## PCN – Process Change Notification

| Change: | AGGP.25F.07.0060A |

| Model#  | Part Number       | Changes   |
|---|-------------------|---|
| AGGP.25F<br>GPS/GLONASS 2 Stage<br>Active Patch 25mm,<br>60mm Ø1.13 | AGGP.25F.07.0060A | To change soldering process from manual to auto soldering machine |

## New Soldering Process

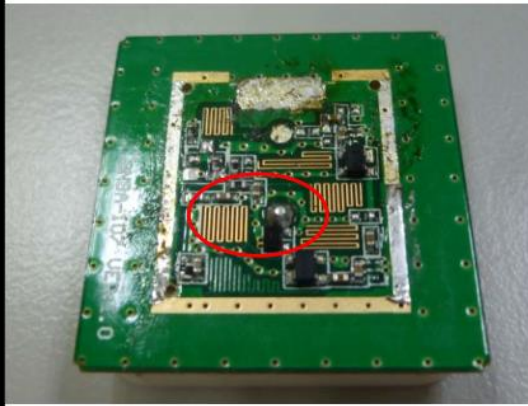
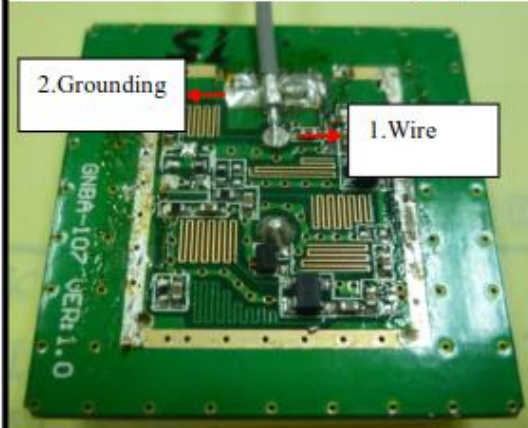
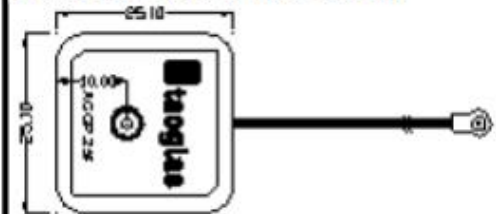
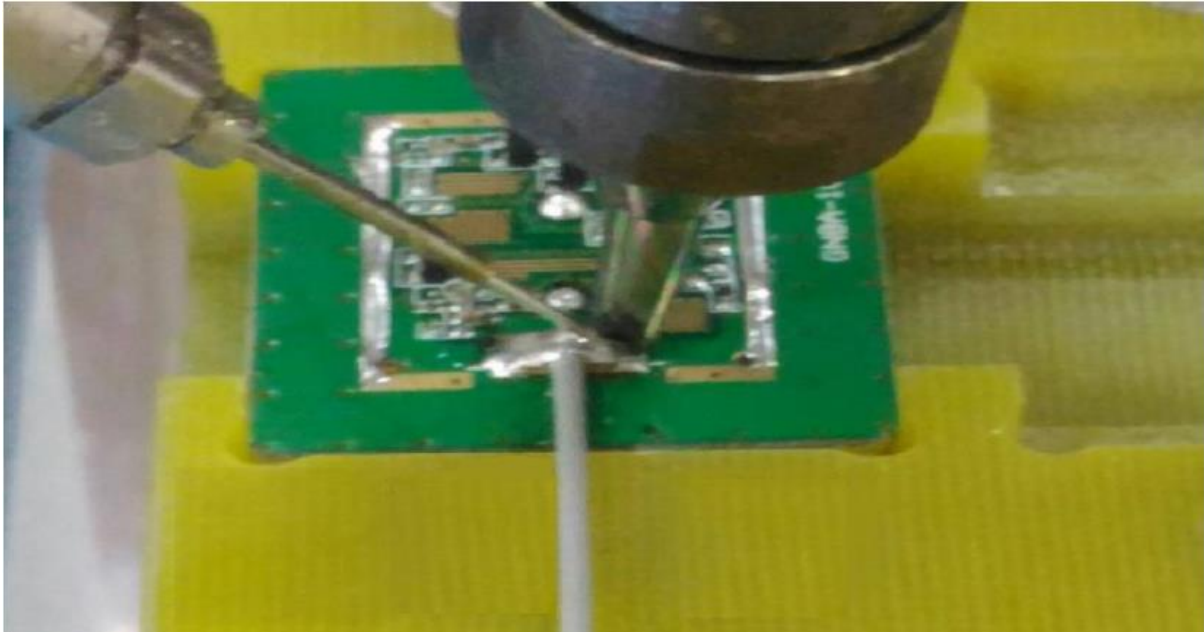
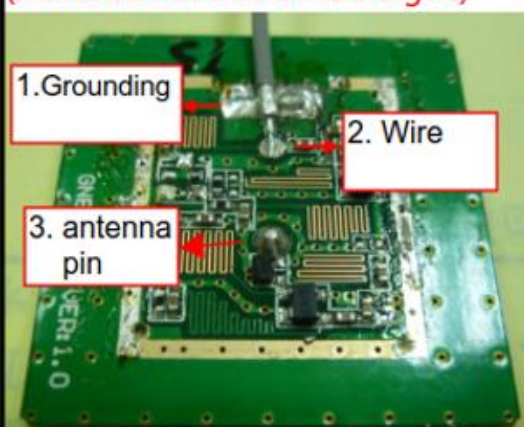
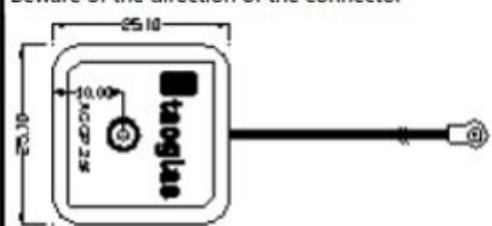
Customer reply to have cable breaking issue, therefore we change the following production procedure to avoid cable breaking.

1. Taoglas has changed soldering process to auto soldering machine, which prevent insulation of Ø1.13 cable melted.
2. Change the soldering order from path antenna pin, core wire, and braid shield to braid shield, core wire, and path antenna pin

1.Place PCBA, soldering step are wire first and then grounding.  
(Insulation cannot be damaged)

Auto soldering machine

| <p>Soldering Cable and antenna pin</p>  | <p>Place PCBA, soldering step are grounding, wire and antenna pin.</p> <p><b>(Insulation cannot be damaged)</b></p>   | <table border="1"> <tr> <td><b>Soldering temp.</b></td> <td>Grounding<br/>Continuous heating time</td> </tr> <tr> <td>380±20°C</td> <td>5sec +/- 2sec / each side</td> </tr> </table> | <b>Soldering temp.</b>                 | Grounding<br>Continuous heating time | 380±20°C | 5sec +/- 2sec / each side |
